# Shenzhen SDMC Technology Co.,Ltd.

## Class II Permissive Change Letter

FCC ID: 2AW68-NP3081GC

### Appearance

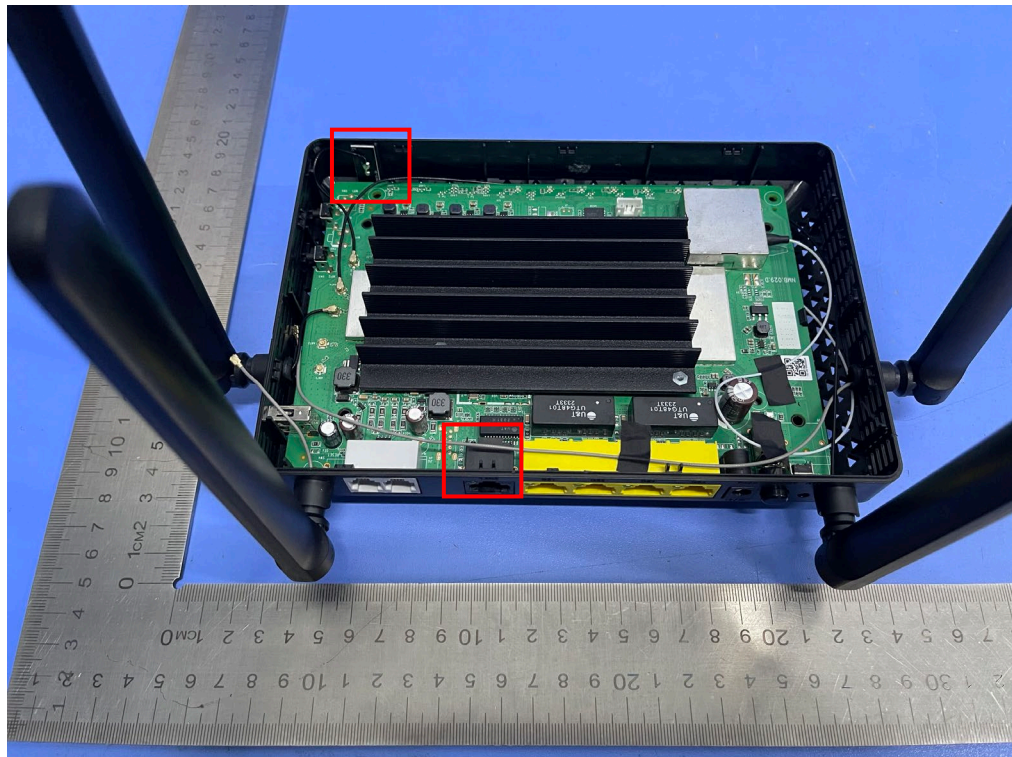
Change the AC/DC adapter, 5.8G built-in antenna and the 2.5G LAN port is deleted, As there is no change regarding RF transmitter portion. The antenna is the same type and the Gain reduces from 5.07dBi to 4.66dBi
